Addendum

PROJECT:
New Administration Building Renovation
3103 Ave. G
Hondo, Texas 78861

ADDENDUM NO.: 2

DATE OF ISSUANCE: September 3, 2024

1 PLUMBING SANITARY SEWER AND VENT FLOOR PLAN
SCALE: 1/4"=1'-0"

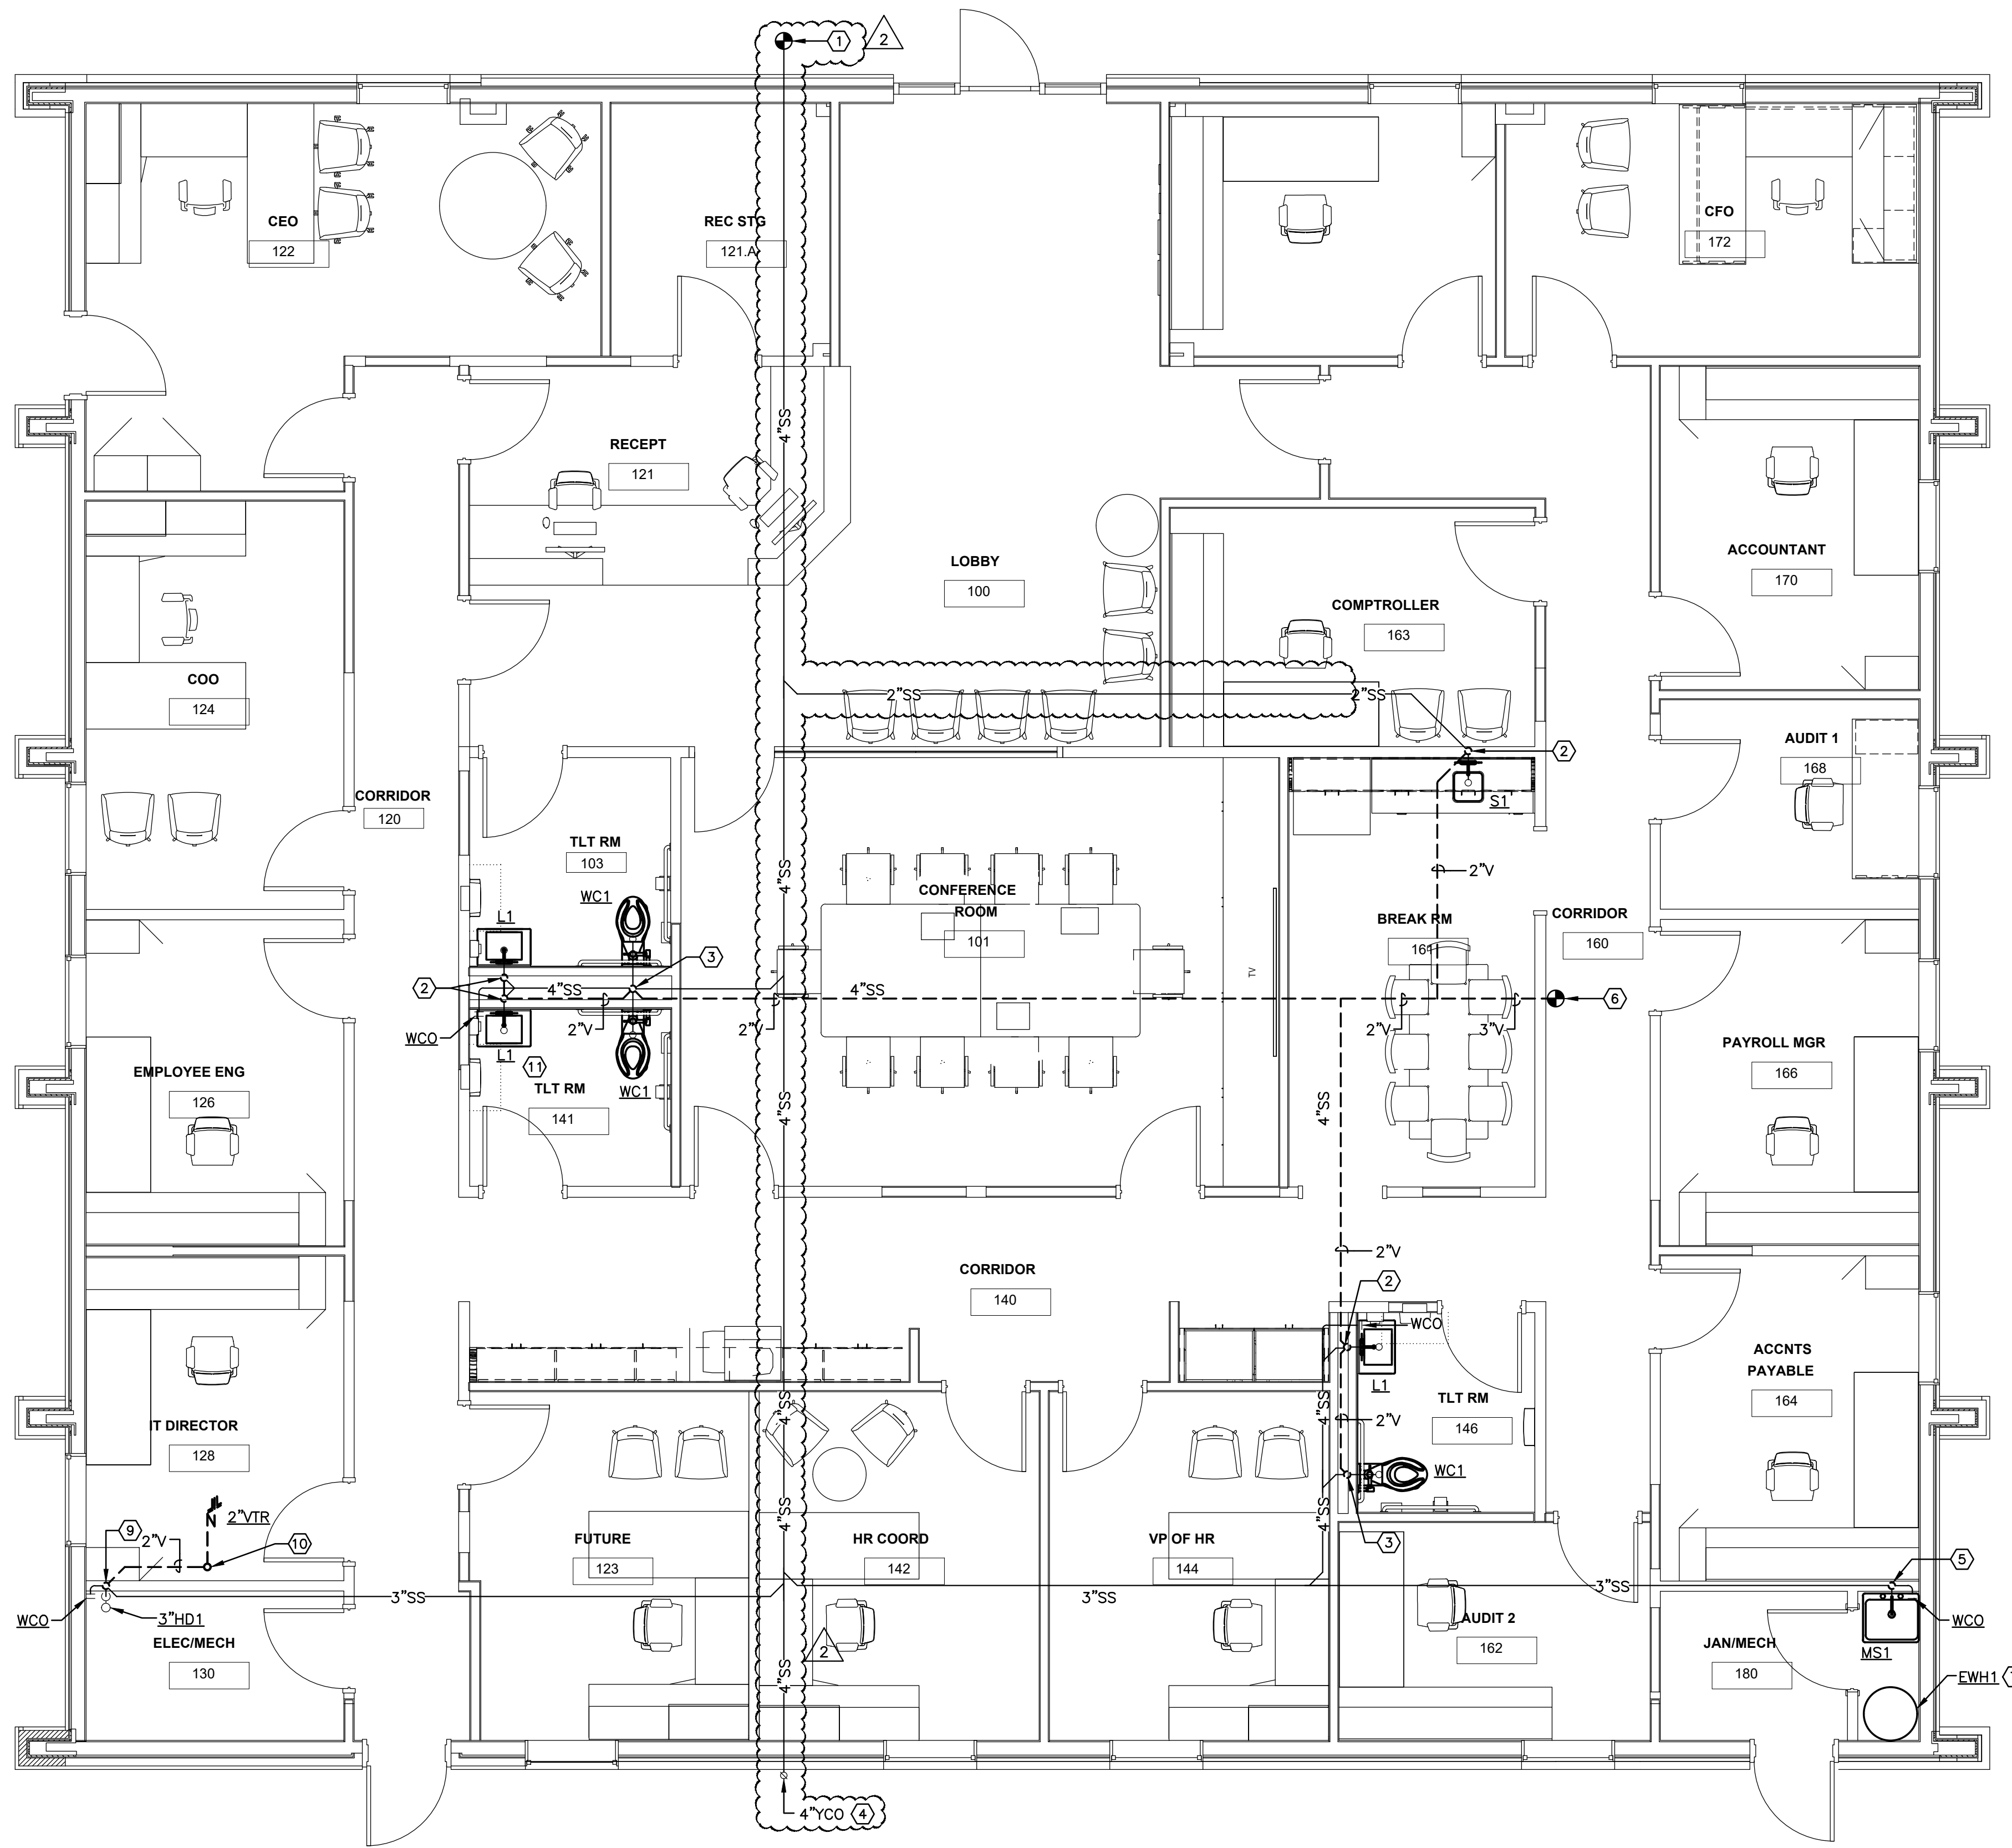
Item	Reference/Description
1.	M-101 – Mechanical – Floor Plans – Level 01 Item 01 – Adjust the transfer ducts in the Conference Room and Copy Area per attached Mechanical Sheet M-101.
2.	P1.1 – Plumbing Sanitary Sewer and Vent Floor Plan Item 01 – Revise the drain and supply lines per attached Plumbing Sheet P1.1.
3.	E101 - Floor Plan - Lighting Item 01 – Add new lighting at the exterior canopy per attached Electrical Sheet E101.
4.	E201 - Floor Plan - Power Item 01 - Add power for new exterior signage per attached Electrical Sheet E201.
5.	E301 - Electrical Symbols and Abbreviations Item 01 - Add Lighting Fixture Type 'D' to the Lighting Fixture Schedule per attached Electrical Sheet E301.

1 FLOOR PLAN - POWER
SCALE: 1/4"=1'-0"

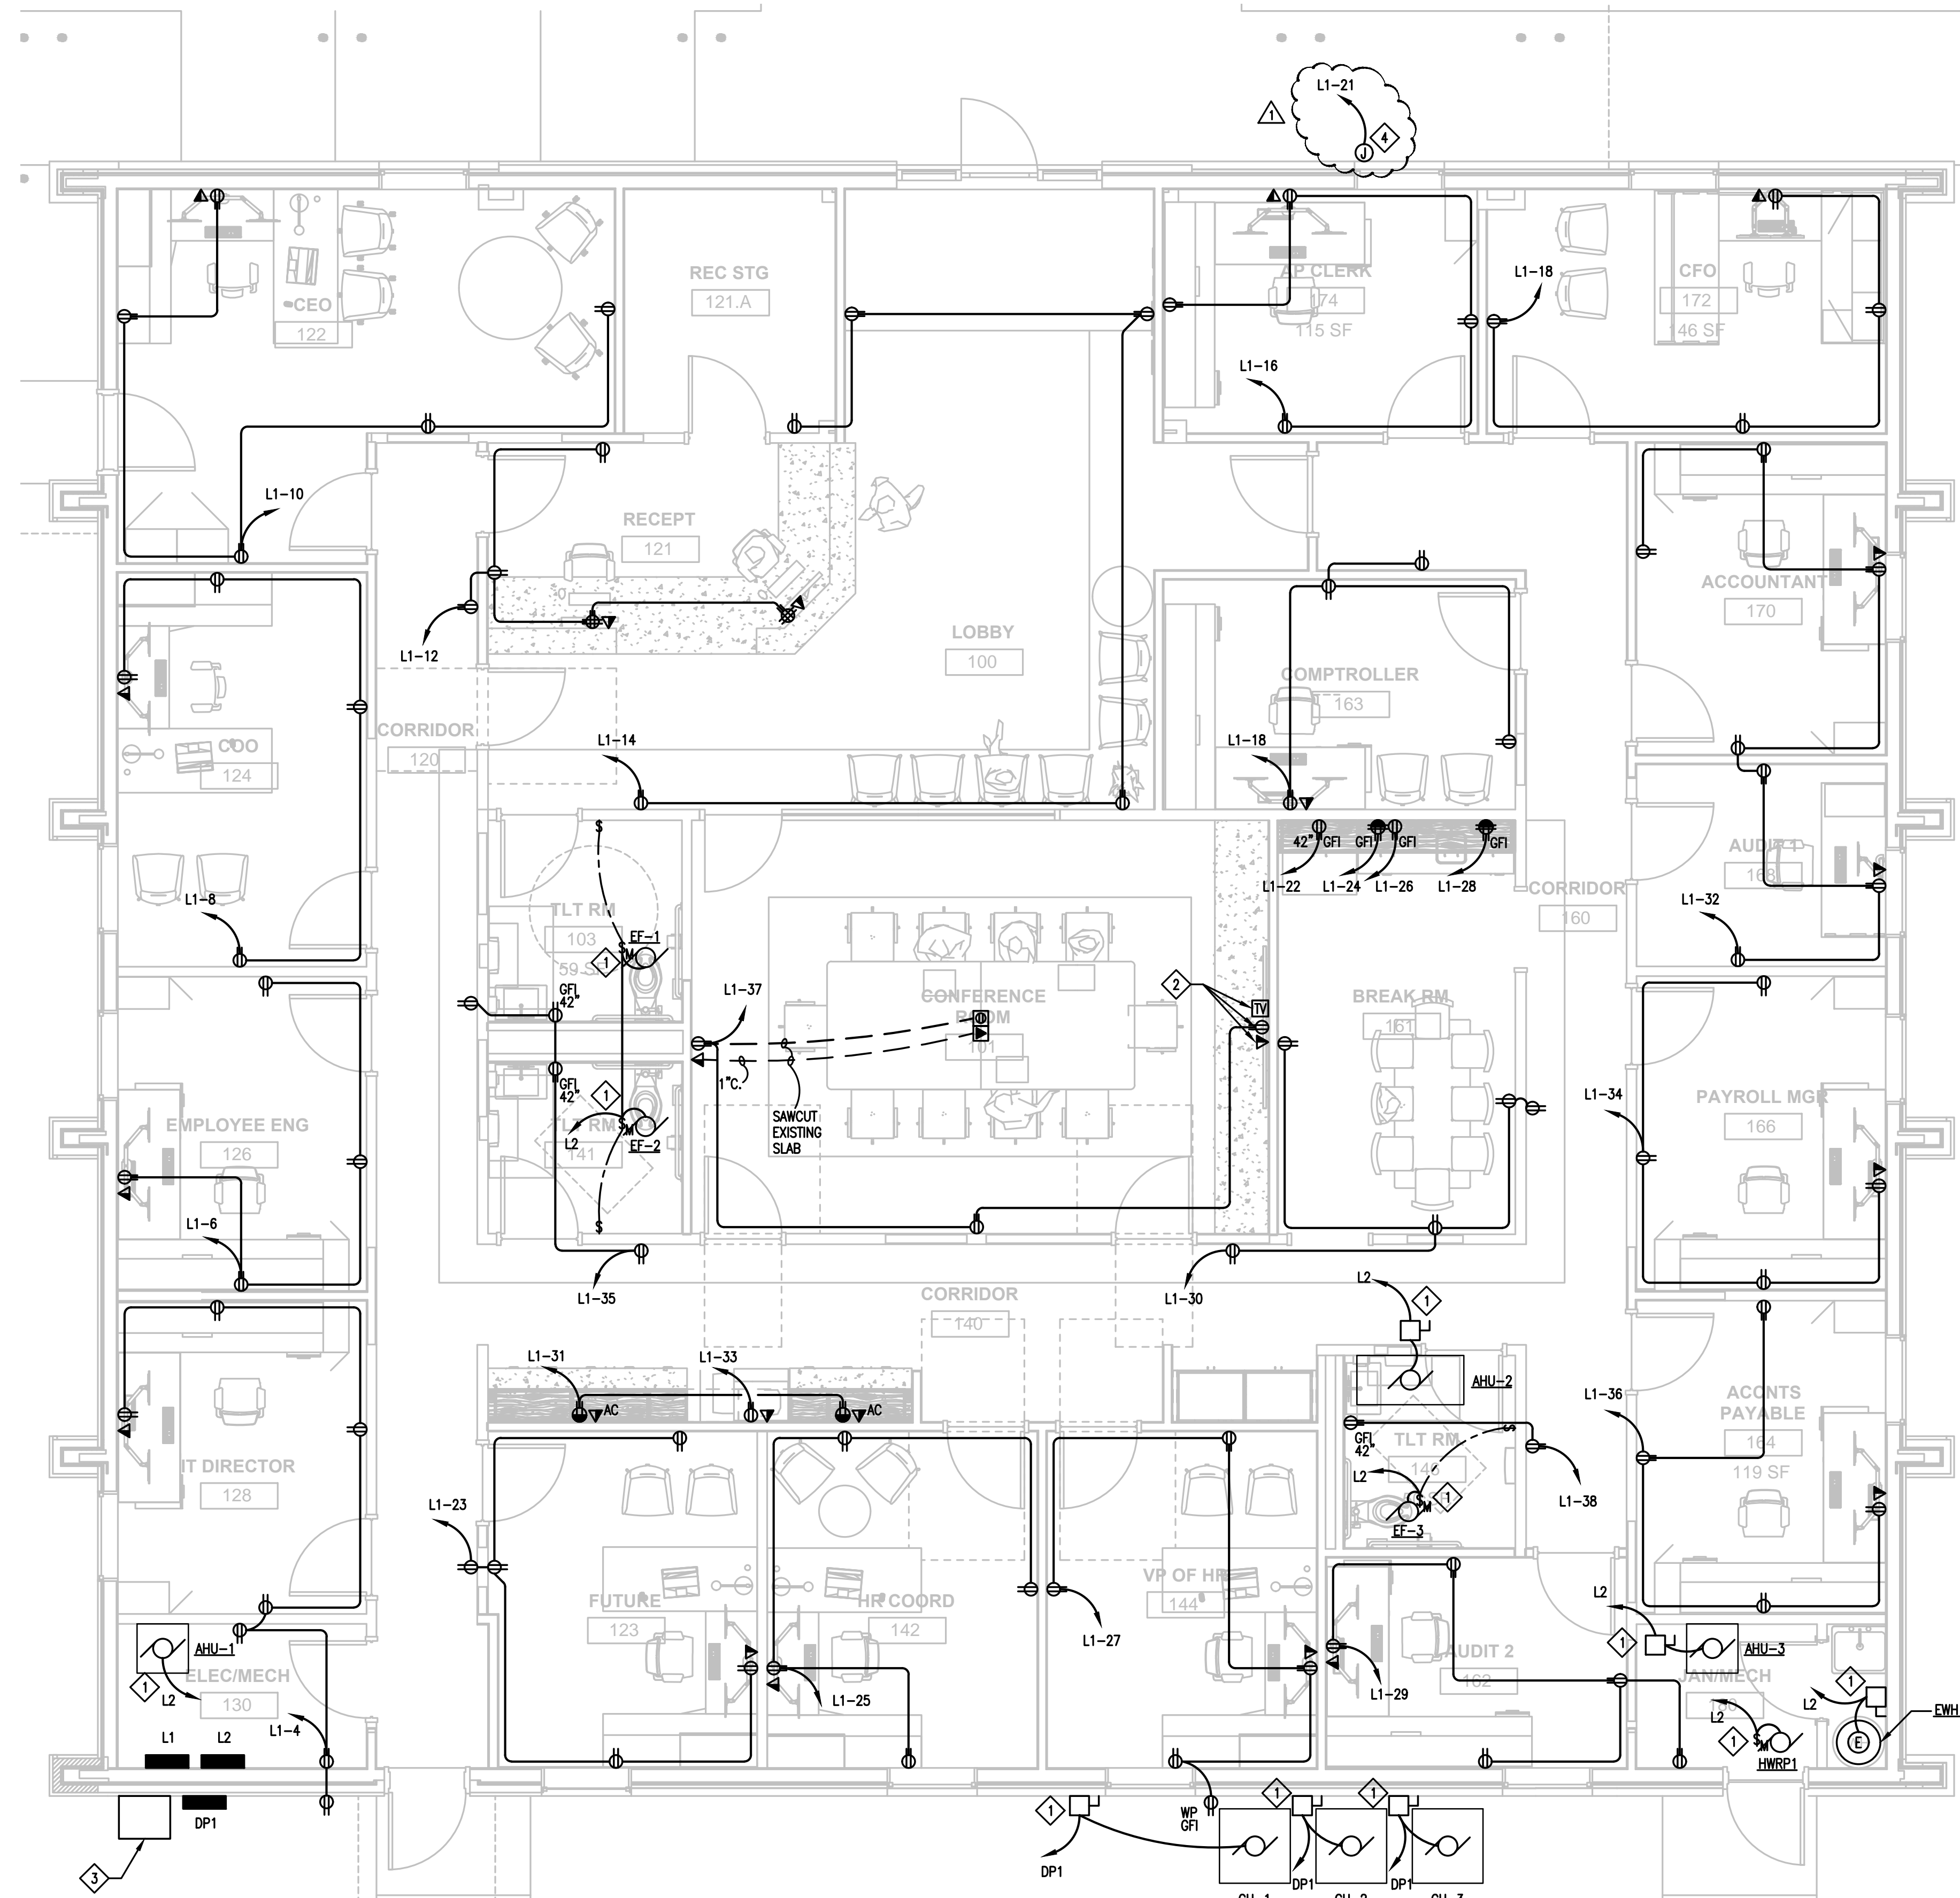
- Accessibility: Ensure compliance with reach ranges and parking dimensions and signage (painted and mounted per TAS and reference sheet G102 – no attachment).
- Architectural: Adjust location of paper towel dispenser in Room 146 (see attached plans).
- MEP: Adjust transfer duct locations; revise drain and water supply locations; add new lighting at exterior canopy; add power for parapet signage; and add light fixture type (see attached narrative and plans).

- SEE MOTOR CONNECTION SCHEDULE ON SHEET E4.0 FOR WIRE, CONDUIT, AND DISCONNECT SIZES AND BRANCH CIRCUIT CONNECTION.
- COORDINATE TV OUTLETS LOCATIONS W/ OWNER.
- 240V 400A NEMA 3R MANUAL TRANSFER SWITCH FOR PORTABLE STANDBY GENERATOR.
- PROVIDE J/BOX AND POWER FOR NEW SIGNAGE. COORDINATE LOCATION WITH TENANT. CONTROL SIGNAGE VIA TIME SWITCH.
